CABINET MEMBER FOR ENVIRONMENT – 27 MARCH 2014

PROPOSED PARKING RESTRICTIONS BURFORD ROAD/MOOR AVENUE, WITNEY

Report by Deputy Director of Environment & Economy (Commercial)

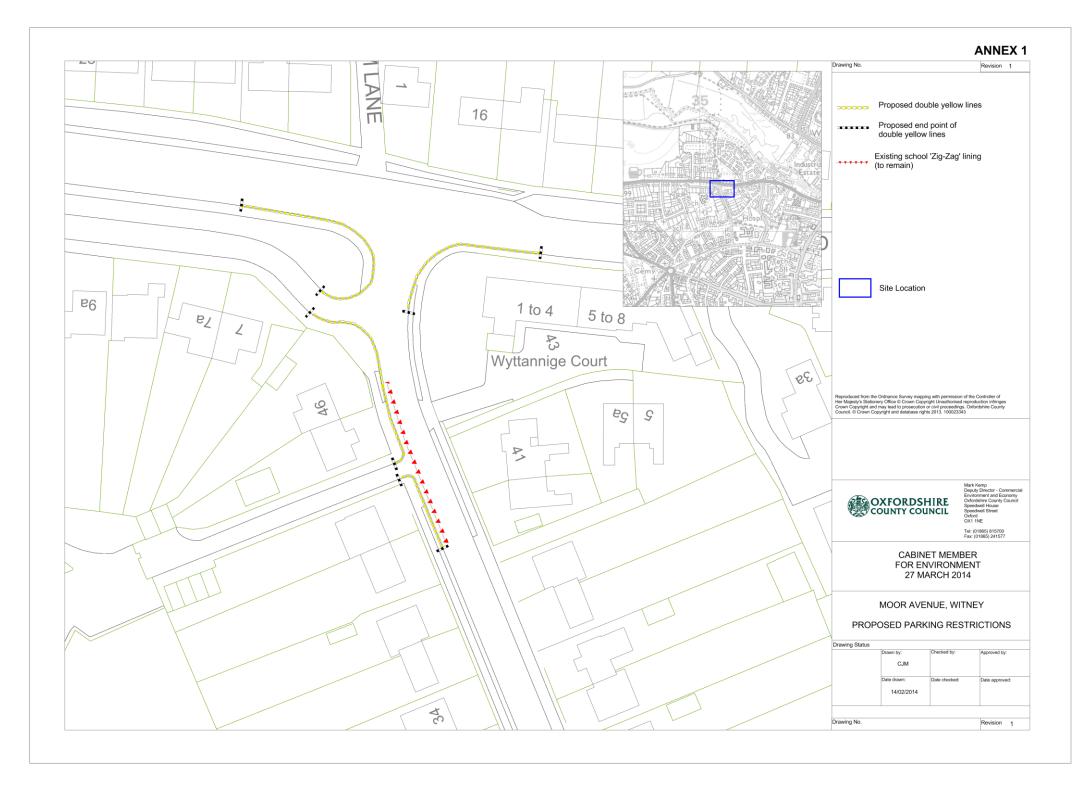
- 5. Three objections were received from residents of Burford Road and Moor Avenue which are summarised at Annex 2. One objection related to a concern that the proposals would lead to a displacement of the parking resulting in significant inconvenience for residents of the Burford Road service road in particular. A related concern was that the proposals should either include waiting restrictions on the full length of the Burford Road service road, or none at all, on the grounds that the plans did nothing to address the present

problems and could risk aggravating them by displacement. The last objection, however, was on the grounds that parents should not face further difficulties in dropping off or picking up children from the school, and that the school time congestion was of very short duration.

OFFICER RESPONSE RESPONDENT COMMENT Thames Valley Following a site visit with local councillors and OCC, residents' concerns Noted. Police about parking controls adjacent to frontages and entrances is reflected in these amended proposals . The shortened section into the Burford Road service road together with extended sections to cover the main A40 junction areas are understood. The school informal zig zag markings are also included appropriately. Thames Valley Police have no further comment or objections to the proposals. By putting double yellow lines in place you will just be moving the Resident It is considered that the reduced **Burford Road** problem further up the road. We suffer from really inconsiderate parking extent of the proposals strikes a when parents collect children from Tower Hill School resulting in reasonable balance between the residents not being able to access or leave their properties during this desire to keep parked cars away from time and getting abusive insults from parents who are waiting to collect the areas where children cross to their children from school. access the school and the need to avoid creating further problems from This is a particular concern as it will likely result in parking on Burford nearby residents. Road that will obstruct access for special schools transport for my son with the potential to cause him and myself great distress; another will face Whilst only advisory, White Access nearby resident potential difficulty. the same Protection markings can be very Either put double yellow lines up all the road or leave as it is. Please do effective in keeping driveways clear in not make the situation any worse by pushing the problem along the situations such as this. road. We are extremely disappointed in your proposed new set of plans for the Resident The earlier proposals received a parking in our cul de sac. The first set of proposed double yellow lines greater number of objections from Burford Road were better than your second effort, which has left us all mystified as to residents these than revised

why you reduced the double yellows to allow more thoughtless parking of school parents cars in the cul de sac. This new proposal does nothing to cure the obstructive parking that goes on further up in the close, the parking over our driveways, the parking in the turning circle at the end and the abuse of parents to residents. All you are doing is curing the parking around the junction but pushing the problem further into our road. This parking restriction does us no favours whatsoever and none of our complaints have been taken into account. The speeding vehicles that race past our houses to the turning circle and then race back to get a space as near to the school as possible is a hazard and danger not only to the residents but to the parents and their children. If you dare say anything you get a mouthful of abuse. You have appeased the school parents by letting them still park wherever they want, and you have done nothing for the residents who live in amongst it all.

Resident Burford Road	Objection on grounds that parents need to drop off and pick up their children from the school. Parents having to park further away would have to unload their younger preschool children, just to take their school child a few 100 yards up the road to school. This would be very stressful for parents and cause unnecessary hardship. Not aware of any accidents at this junction and the congestion that the school run causes is only for a very short while in the morning and after school.	The proposals are intended to keep parked cars away from the areas where children cross the road to access the school.
Resident Moor Avenue	The planned proposal of double yellow lines at the Burford Rd, Moor Ave is an excellent idea but regulations are of little use if they are not enforced. There is chaos when the school day starts and ends. Would consideration be given to the placing of some posts or bollards on the corner near No. 46 to prevent vehicles blocking the kerb and parking on this pavement?	Noted. The parking restriction applies to the footway as well as the carriageway so bollards should not be required, but this will be kept under review.
